FLOOD RISK ASSESSMENT

**PROPOSED RESIDENTIAL DEVELOPMENT
CALLIARDS MILL
SMITHY BRIDGE ROAD
LITTLEBOROUGH
ROCHDALE
OL15 8HP**

Doc Ref: rep-tjba-hallmark-calliards mill-FRA-010725.docx

Revision	Date	Reason
0	Jul 2025	Original to support planning application.
1	Jun 2026	Title Page Doc ref corrected. Gen update to address EA comments/concerns.
2	August 2026	Minor amendments to report, site plan changes.
3	August 2026	New site plan.

3.3 Proposed Plan.

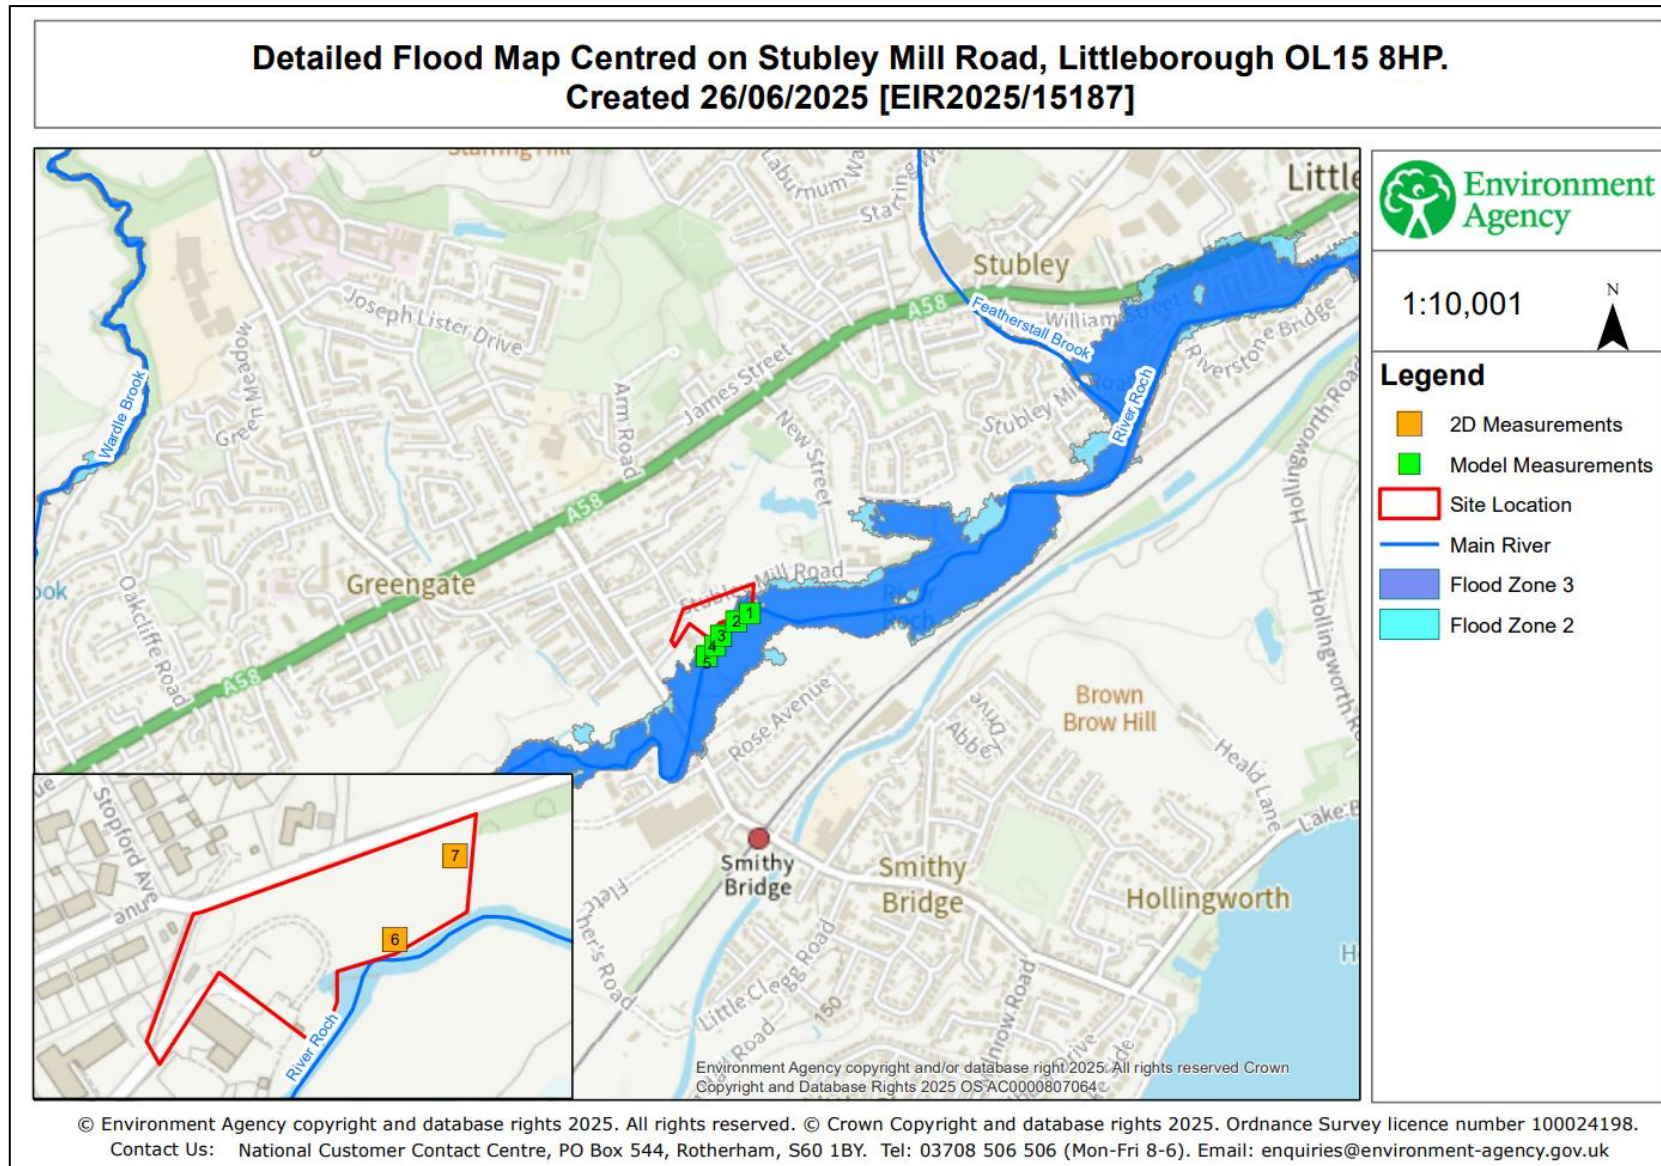
- *'Whilst the proposed finished floor levels for this development appears to suitably account for the flood levels from the Roch, the FRA also refers to raising the existing topography. We would need to see a more detailed plan and site layout at a closer scale and more information about the proposed topography changes to properly understand the impact on finished floor and flood levels, as well as understanding access and egress arrangements.'*

- The original FRA (revision 0 of this report) never referred to raising the site topography.
- For clarity, we have included further information in sections 2.8.3 Existing Site Plan, and 2.8.4 Proposed Site Plan; in order to clear up any misreading of the FRA. In it I have stated that there are no proposed changes in topography, and that the proposed buildings and associated garden areas are to be erected on the higher part of the site, and follow the existing site levels/topography.
- Following the existing levels will ensure there are no impacts on access/egress or finished floor levels, which will be well above the extreme flood level.
